**UT to Town Creek Restoration Project – Option A
Year 2 Monitoring Report**

DMS Project ID Number – 94648; NC DEQ Contract No. 003277

Subject: Task 8: Annual Final Monitoring Report – Monitoring Year 2 & Response to Comments
UT to Town Creek Restoration Project – Option A
Yadkin River Basin – CU# 03040105 – Stanly County, NC
NCDMS Project ID No. 94648; NCDEQ Contract No. 003277

NC Center for Geographic Information & Analysis

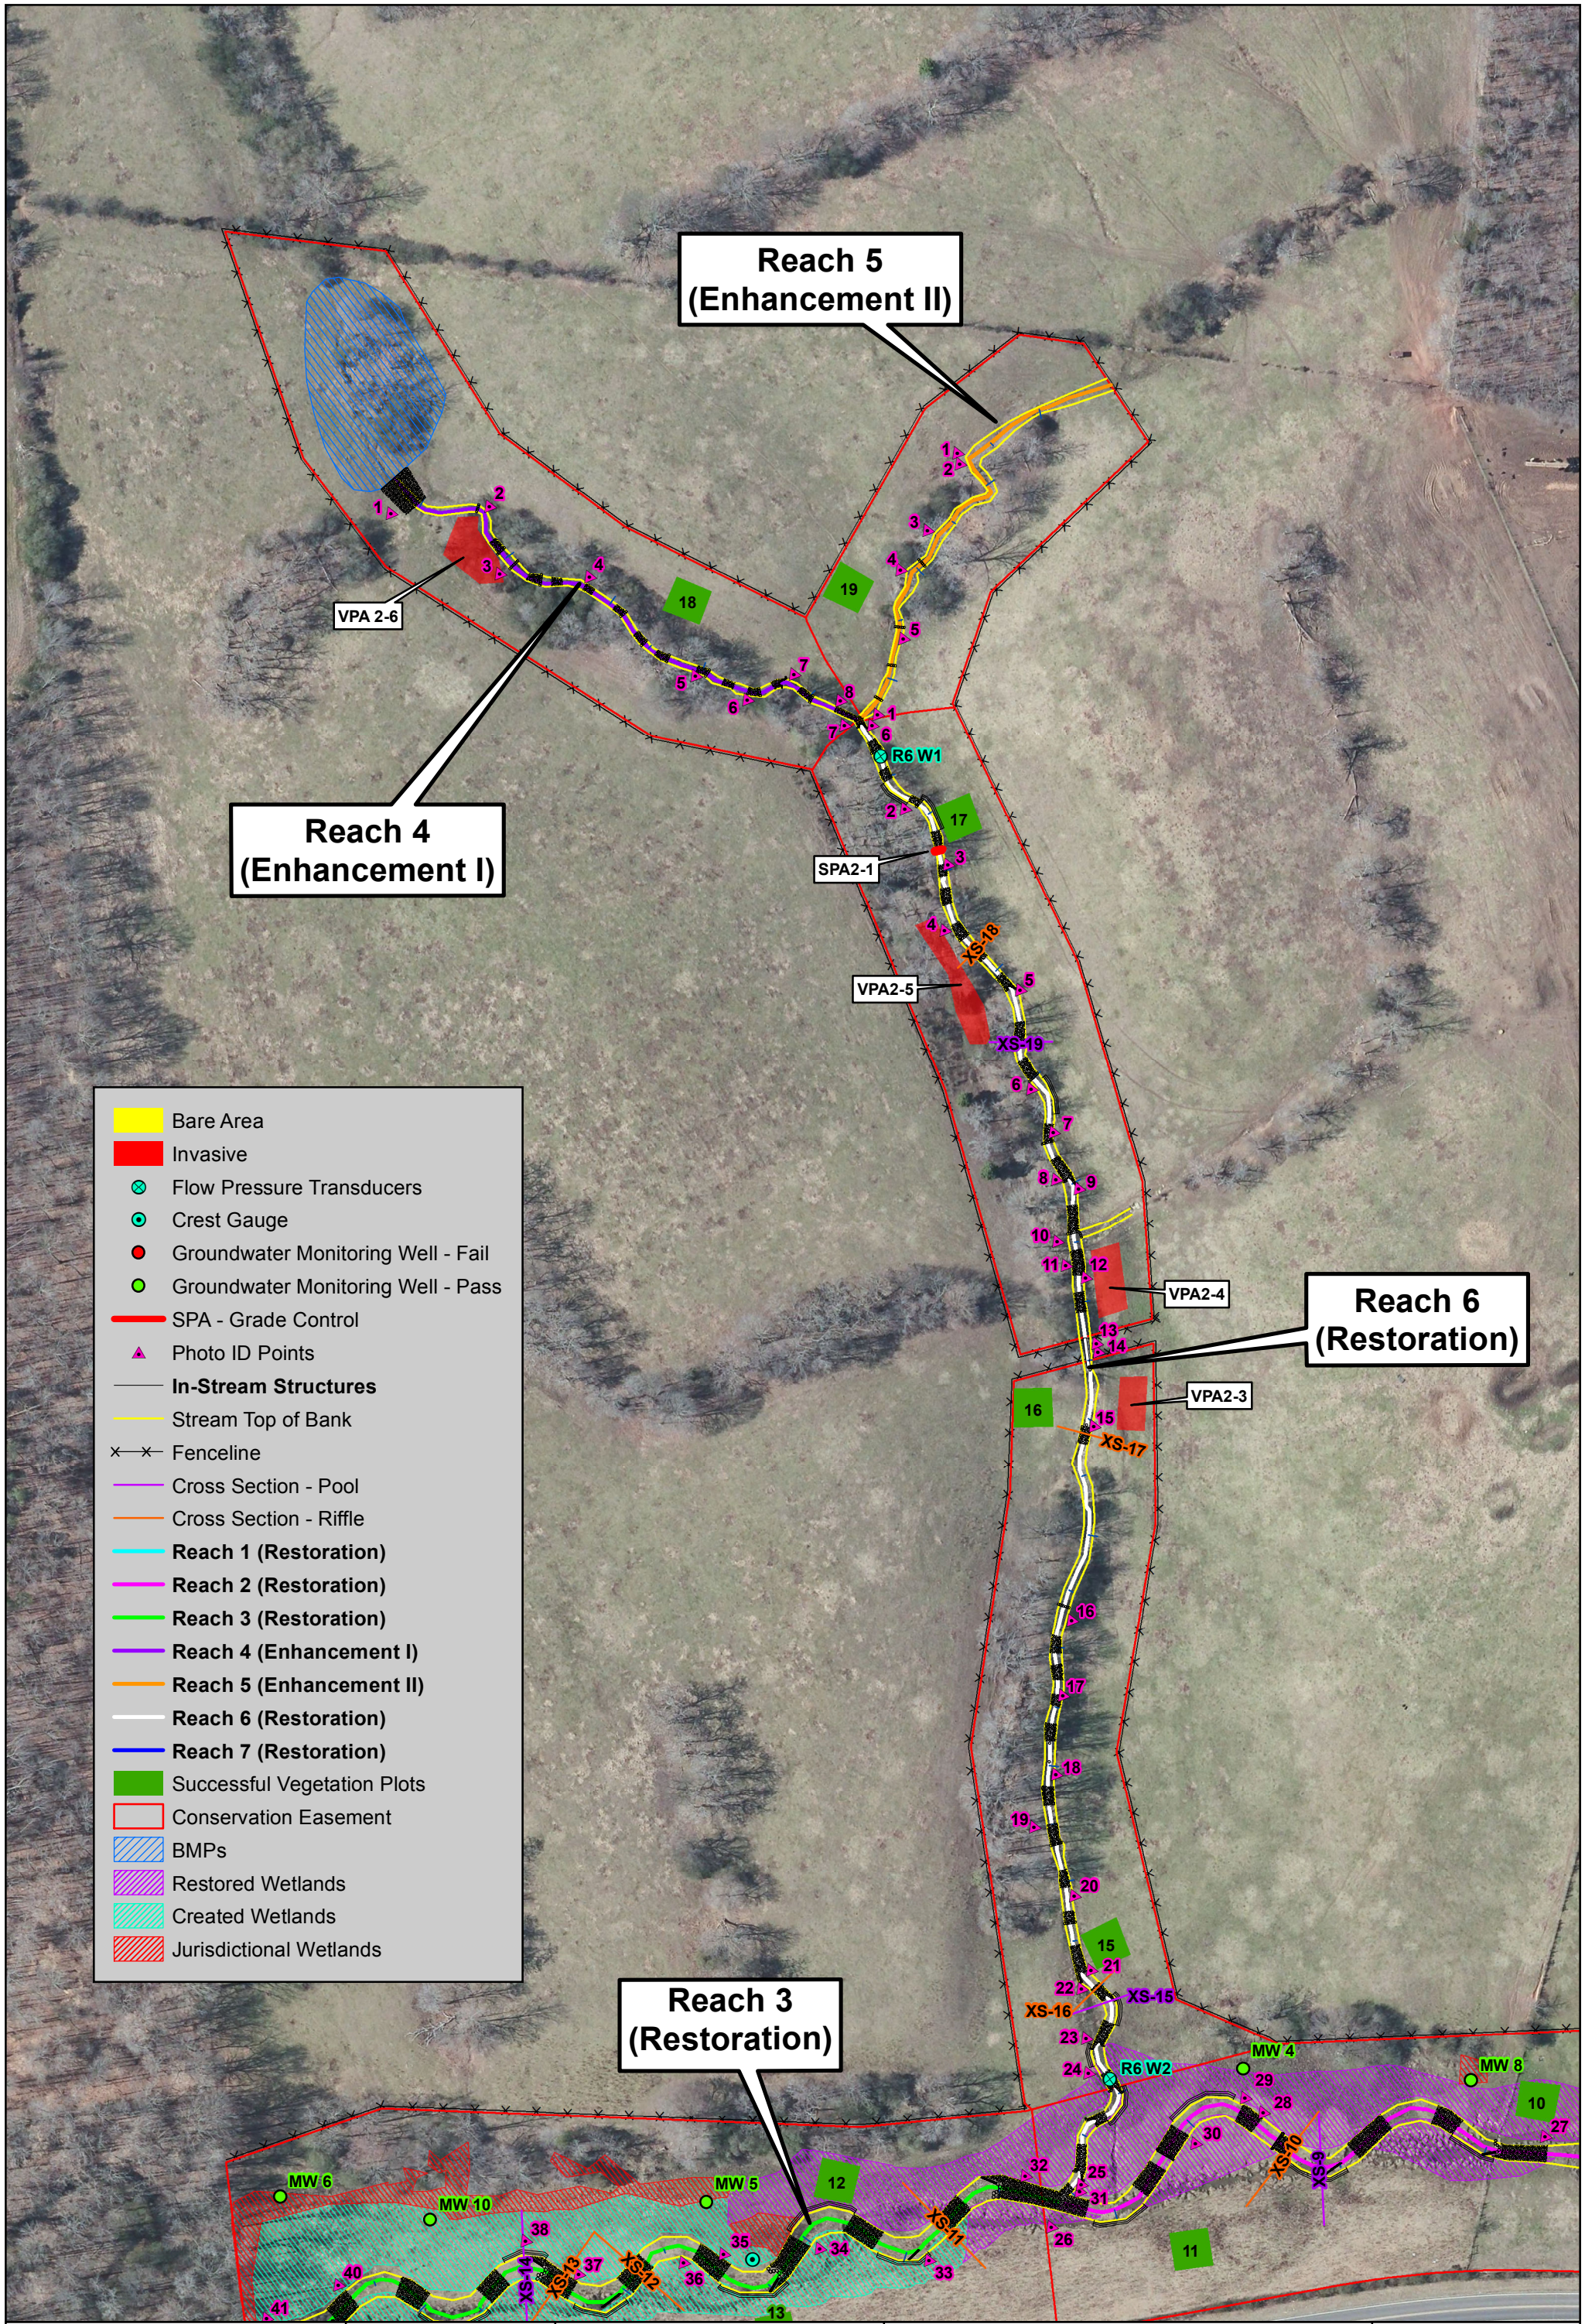
Figures 2a through 2c - Figures should be printed on 11x17 as they were in the MY01 report. Project monitoring features are not legible at the submitted print size / scale.

It would be preferable to show the stream segment for each asset type in a unique color rather than callouts to be consistent with most DMS monitoring reports. If that is not possible please show the reach breaks clearly. For example, Figure 2B shows point-callouts for Reach 2 and Reach 3 but it is not clear looking at the figure where the break point is between Reaches 2 and 3; e.g., is it the roadway/culvert or the confluence with Reach 6?

Response – Figures 2 – 2c have been printed on 11x17 sized paper. As requested, each reach has been identified with a distinct color to clearly define the reach on the CCPV maps (Figures 2 – 2C)

Figure 3. Cross-sections with Annual Overlays
UT to Town Creek Restoration Project - Option A: Project No. 94648

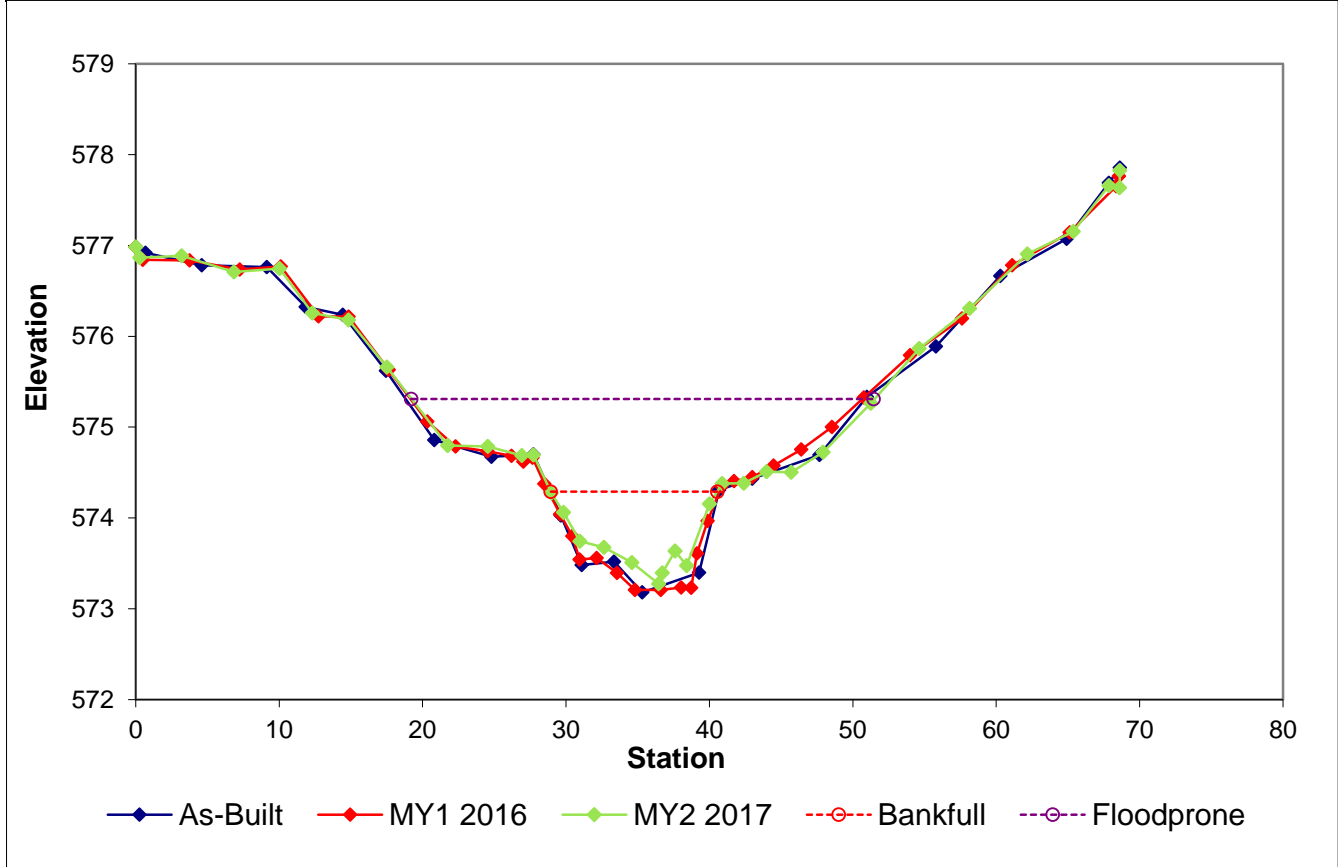
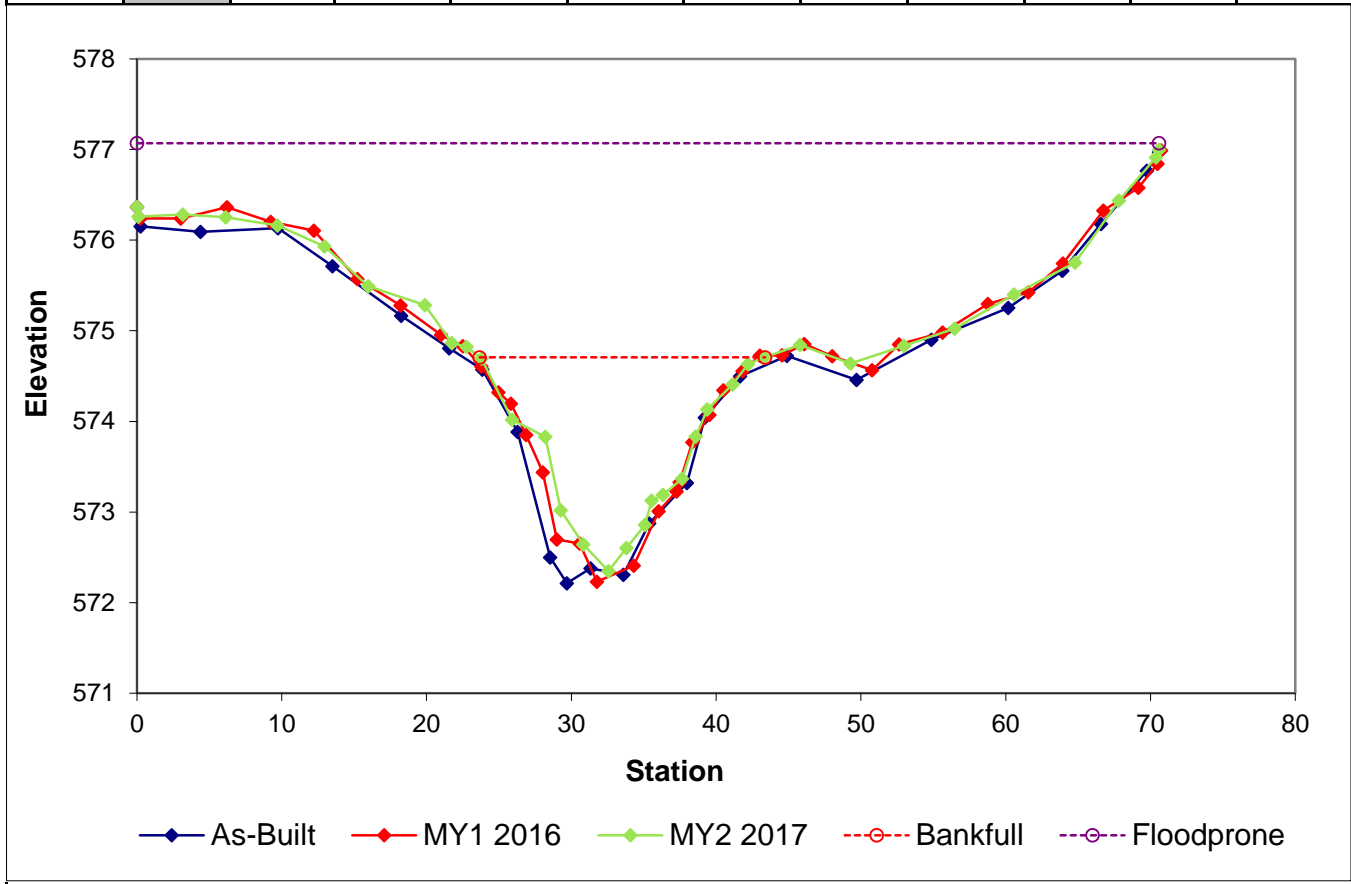
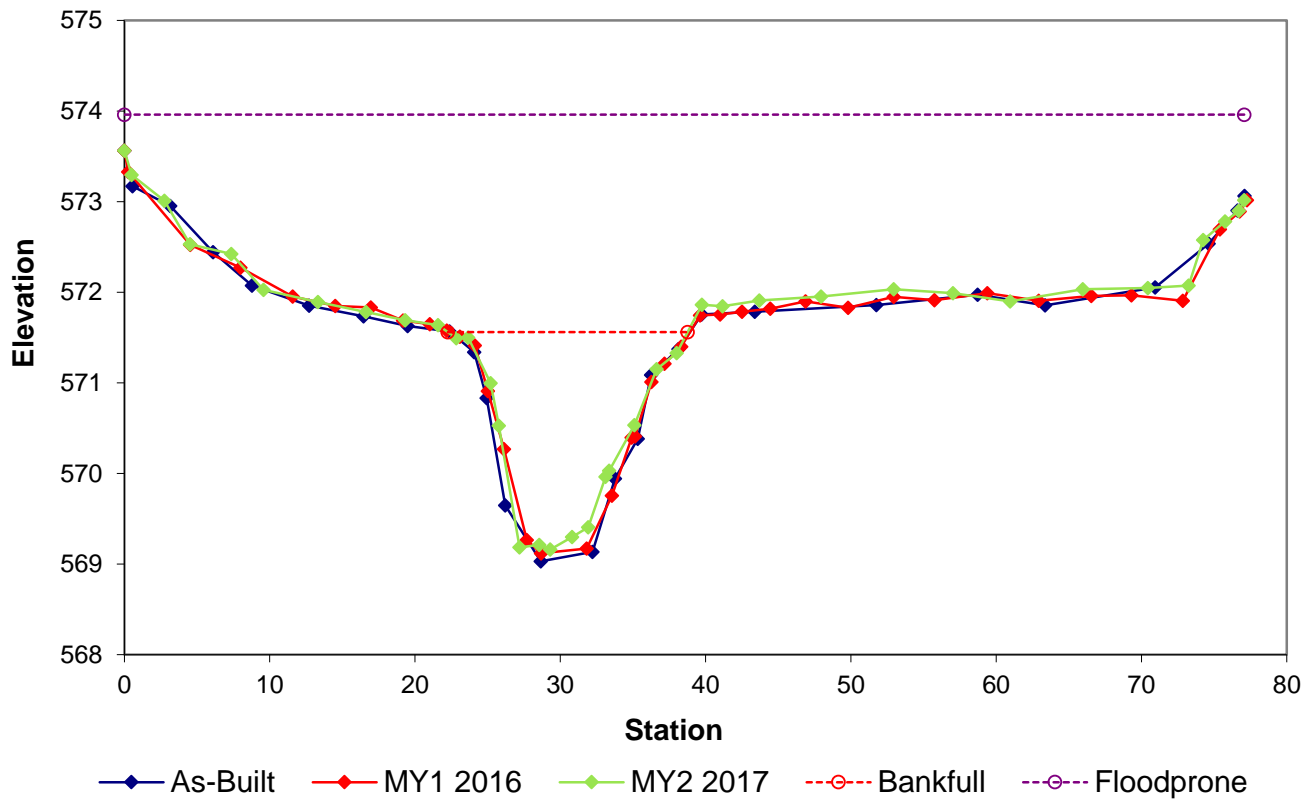
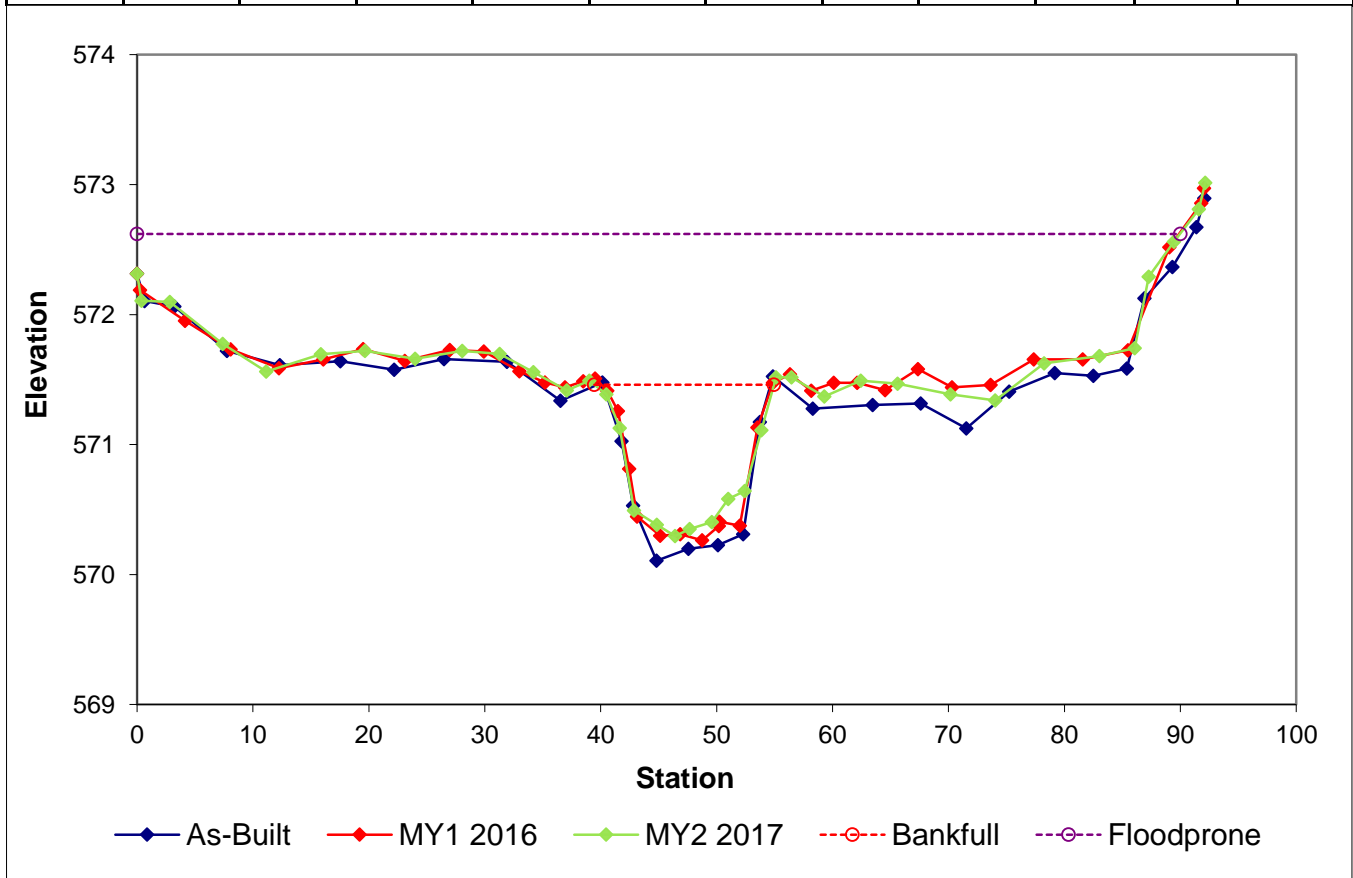
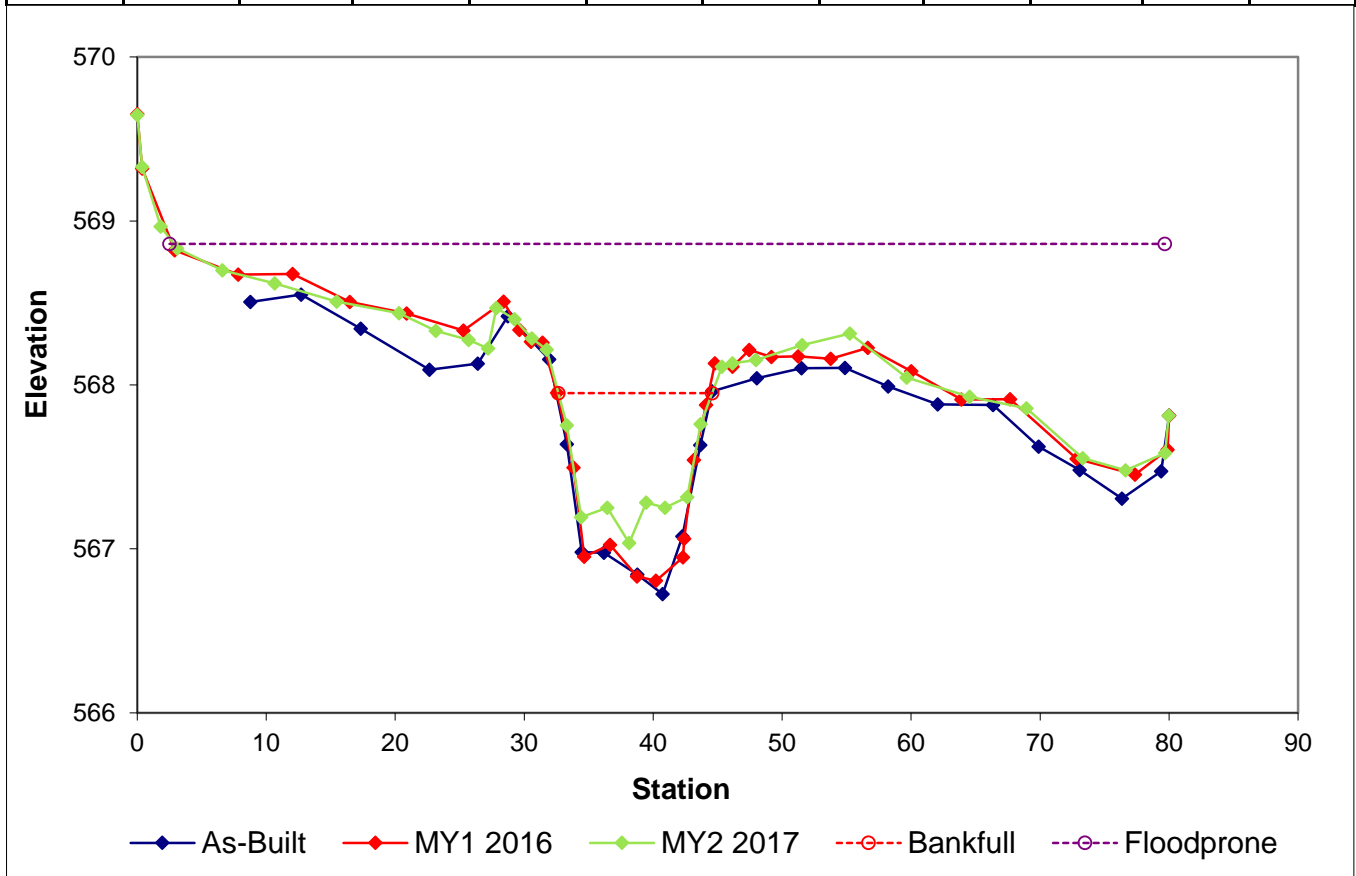
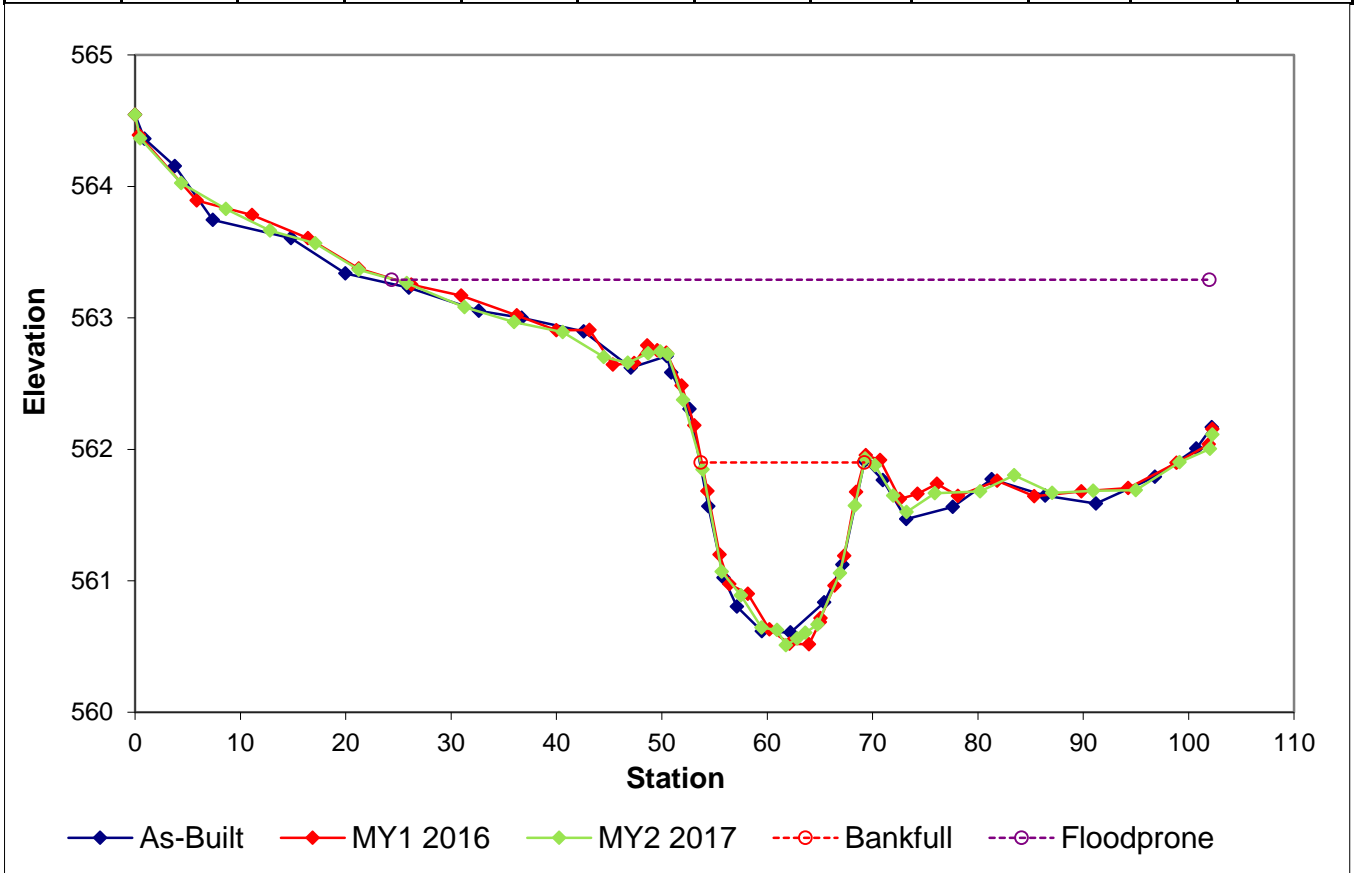
Cross sections – Reported bankfull elevations have changed from MY01 to MY02. These were set and consistent from MY0 to MY01. Bankfull elevation and the bankfull depth should remain static and reflect MY0 conditions for the purposes of monitoring changes/trends in the BHR. TOB elevation (the depth from the thalweg to the low TOB) may change throughout monitoring period. Please update the cross sections and data tables accordingly.

Response – Bankfull elevations have been updated to reflect MY0. In addition, max BKF depth, BH ratio, and ER have been revised where appropriate. Cross-sections and cross-section morphology and have been updated to reflect changes in summary data. A footnote has been added to all associated tables to reflect these changes. For riffles the footnote is stated as follows:

“ Max BKF depth was calculated from the As-built survey only for riffles. BH ratio was calculated using current year's low bank depth divided by the as-built year's max BKF depth. ER was calculated using the current year's floodprone width divided by the as-built BKF width.
**Recorded BKF elevation reflects the as-built survey BKF elevation.”*

For pools the footnote is stated as follows:

*“*Recorded BKF elevation reflects the as-built survey BKF elevation.”*
